THOMAS & STEPHANIE GLENN RESIDENCE
654 SW TIMUQUA TERRACE
FT. WHITE, FLORIDA 32038

SHEET
1 OF 7
FLOOR PLAN

Ref: Ridge Beam Revision
 Thomas and Stephanie Glenn Residence
 654 SW Timuqua Terr
 Fort White, FL 32038

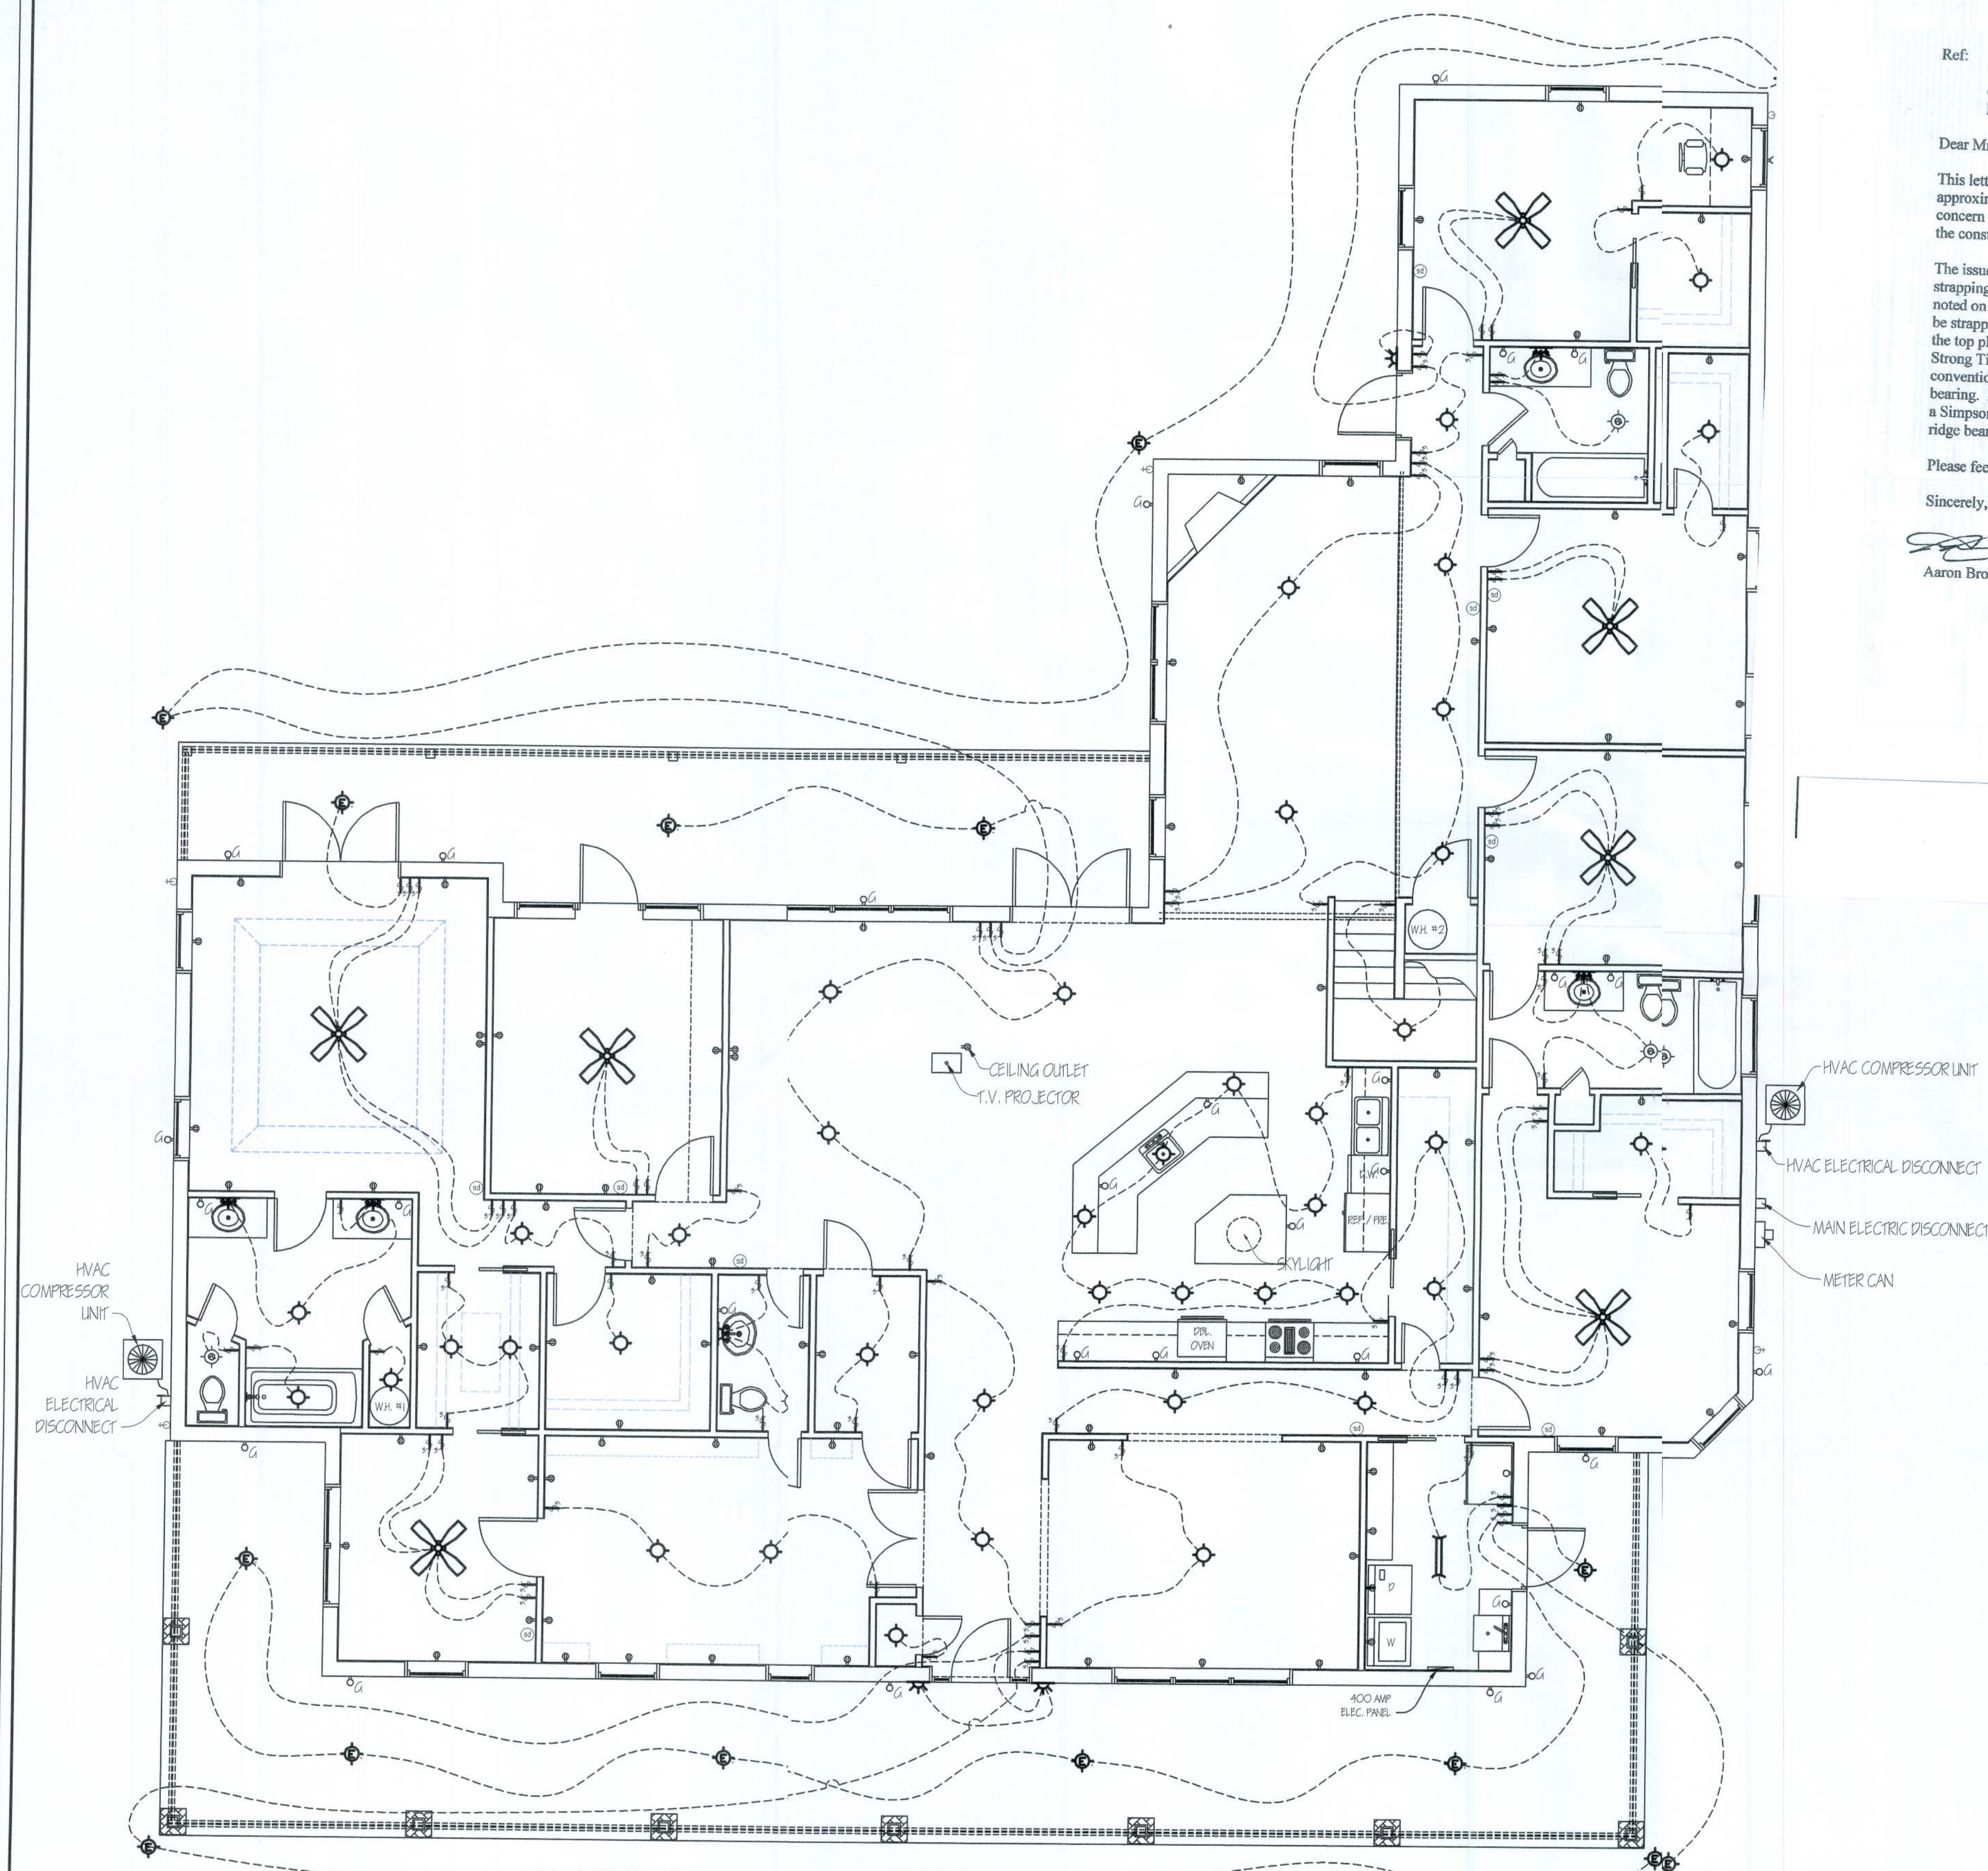
This letter is in reference to our conversation the morning of June 24, 2010 at approximately 8:30 a.m., concerning the aforementioned project and the issues of concern upon plan review. This letter shall be inserted to the plan set and made a part of the construction documents, for revision and correction.

The issue of concern consists of the LVL ridge beam nailing patterns, connections, and strapping. The ridge beam will consist of a 3 ply 1-3/4" x 23-7/8" LVL fastened as noted on drawing 4 revisions to sheet 4 (attached). Each end of the LVL ridge beam will be strapped with two (2) LSS0 Simpson Strong Tie from the vertical face of the LVL to the top plate of the conventional framed bearing as well as two (2) HTS20 Simpson Strong Tie twist straps from the vertical face of the LVL to the vertical face of the conventional framed bearing wall. The LVL ridge beam will have a minimum of 6" of bearing. Each 1-3/4" x 14" LVL roof joist will be fastened to the LVL ridge beam with a Simpson Strong Tie LSSU125 and a LSTA30 Simpson Strong Tie over the top of the ridge beam and fastened to each roof joist 1-3/4" top face.

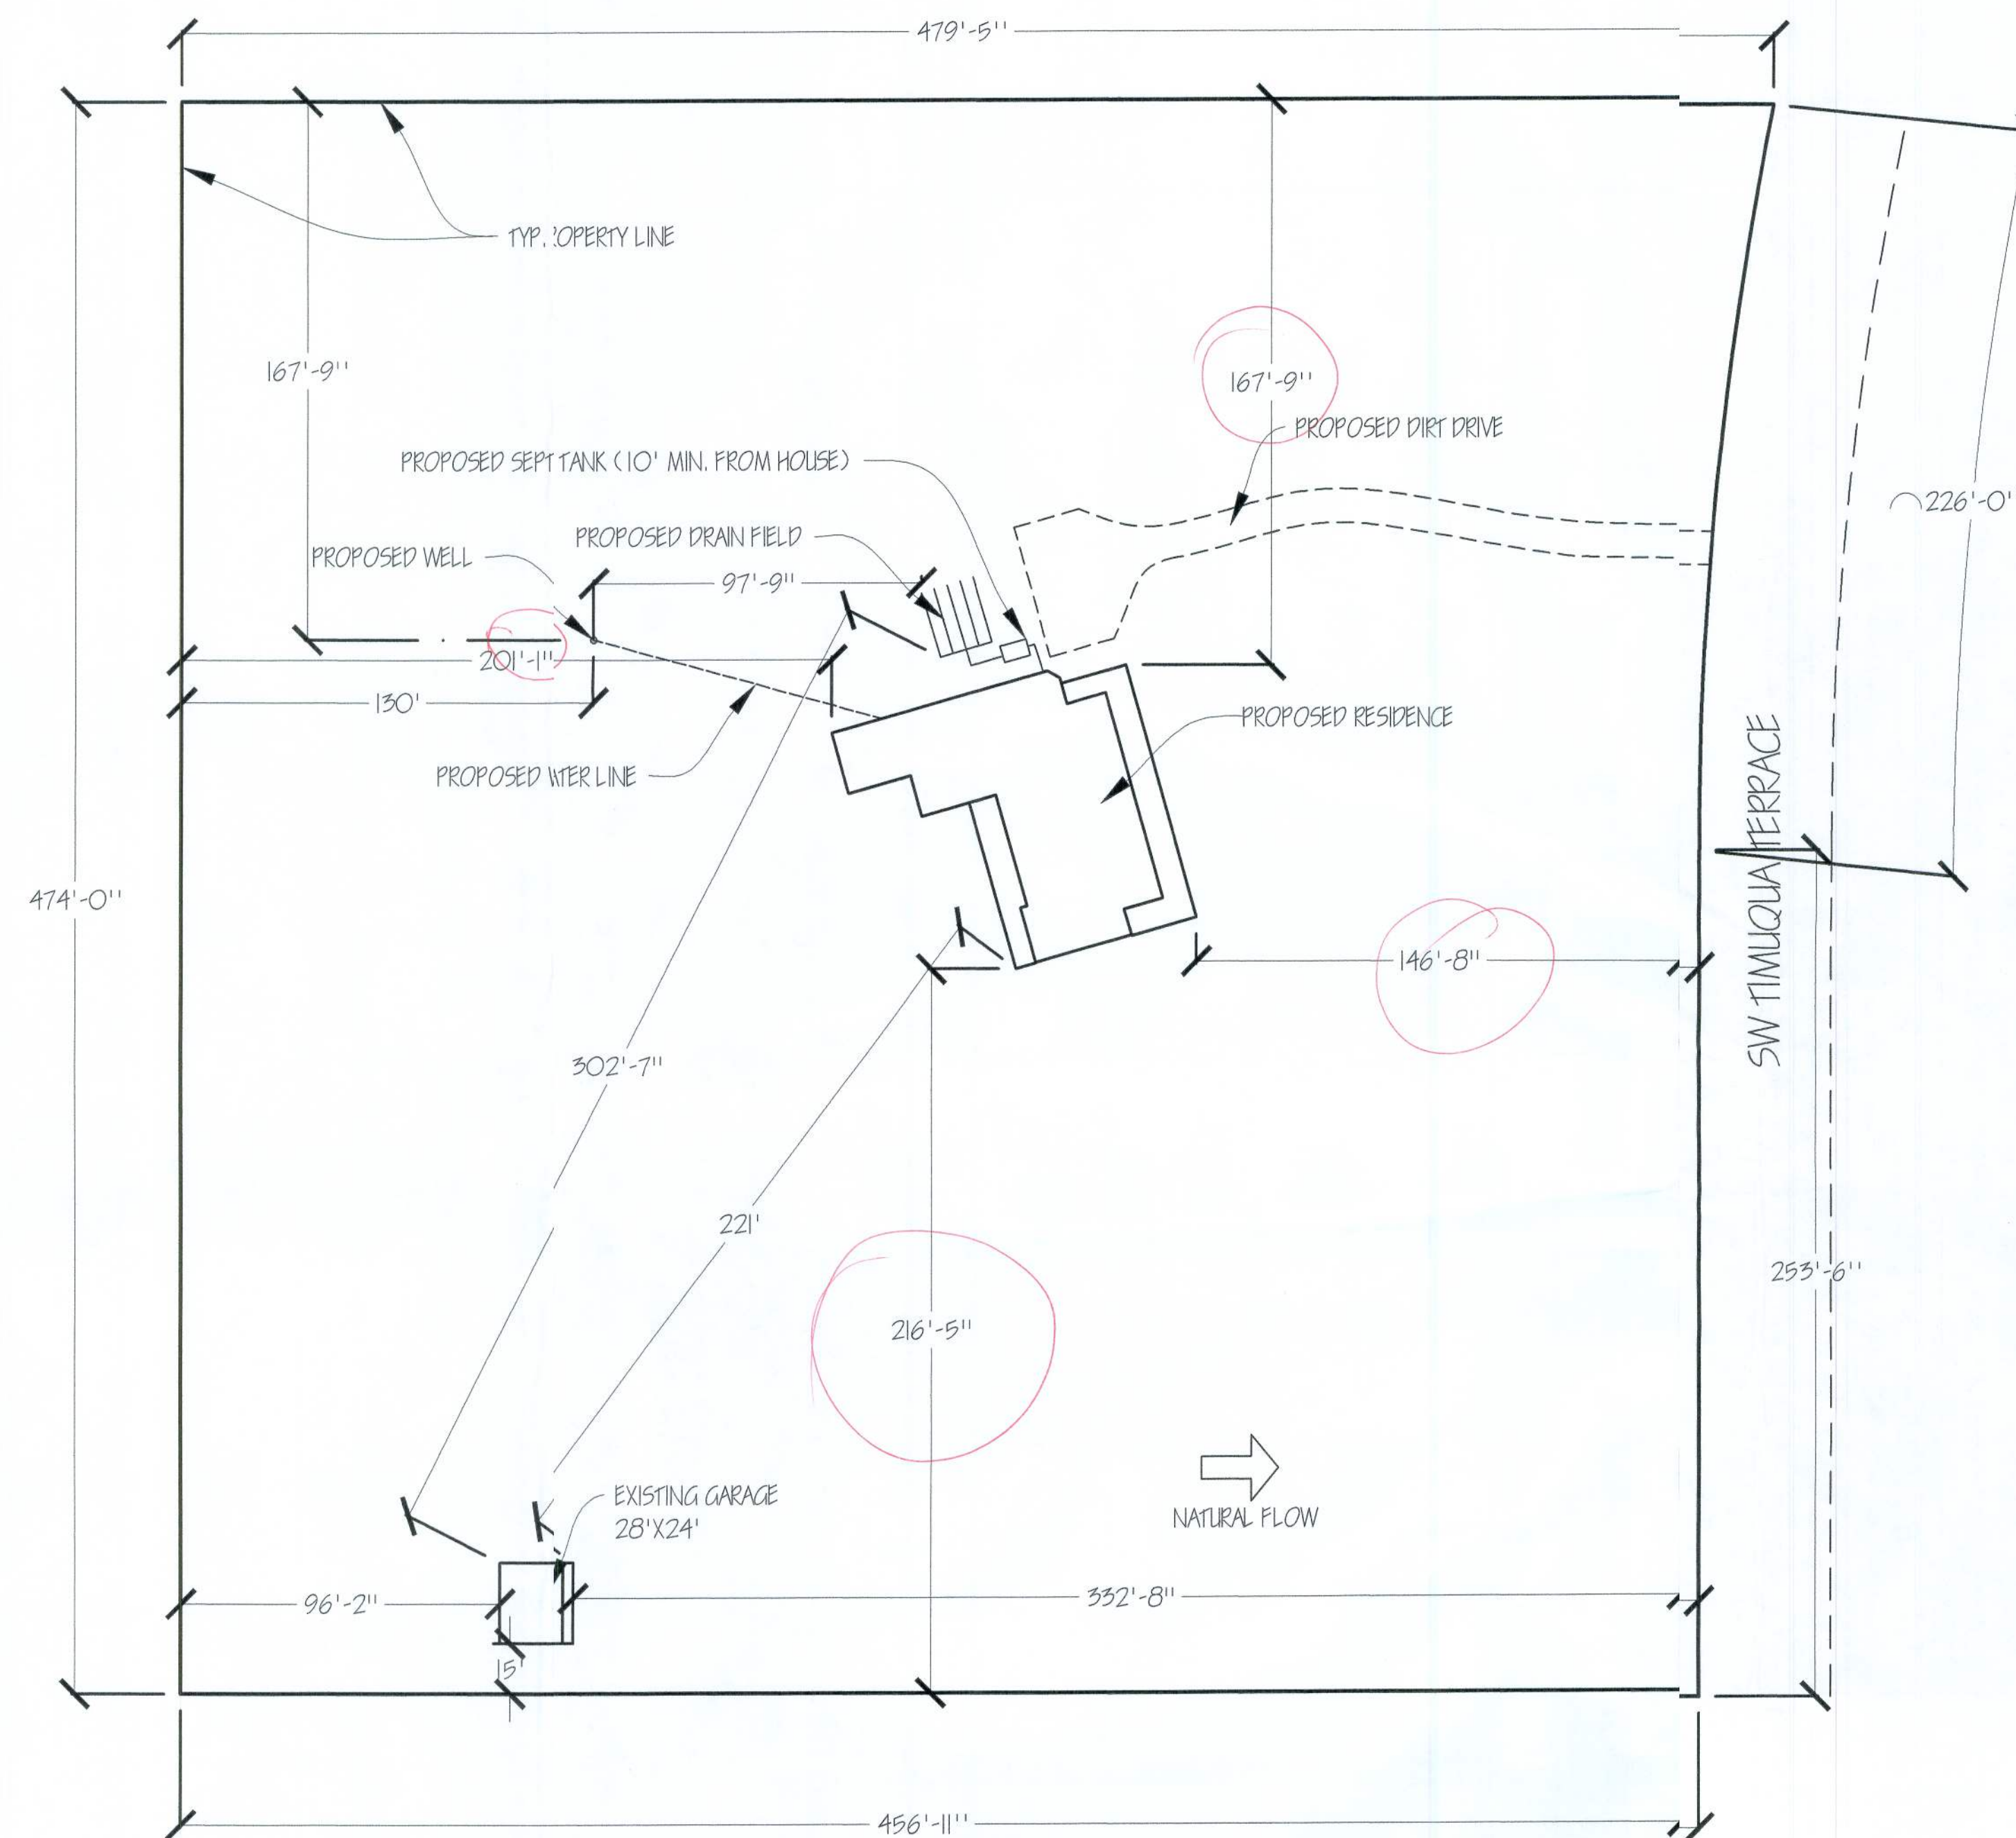
This letter is in reference to our conversation the morning of June 24, 2010 at approximately 8:30 a.m., concerning the aforementioned project and the issues of concern upon plan review. This letter shall be inserted to the plan set and made a part of the construction documents for revision and correction.

The issue of concern consists of the LVL ridge beam nailing patterns, connections, and strapping. The ridge beam will consist of a 3 ply 1-3/4" x 23-7/8" LVL fastened as noted on drawing 4 revisions to sheet 4 (attached). Each end of the LVL ridge beam will be strapped with two (2) LSS0 Simpson Strong Tie from the vertical face of the LVL to the top plate of the conventional framed bearing as well as two (2) HTS20 Simpson Strong Tie twist straps from the vertical face of the LVL to the vertical face of the conventional framed bearing wall. The LVL ridge beam will have a minimum of 6" of bearing. Each 1-3/4" x 14" LVL roof joist will be fastened to the LVL ridge beam with a Simpson Strong Tie LSSU125 and a LSTA30 Simpson Strong Tie over the top of the ridge beam and fastened to each roof joist 1-3/4" top face.
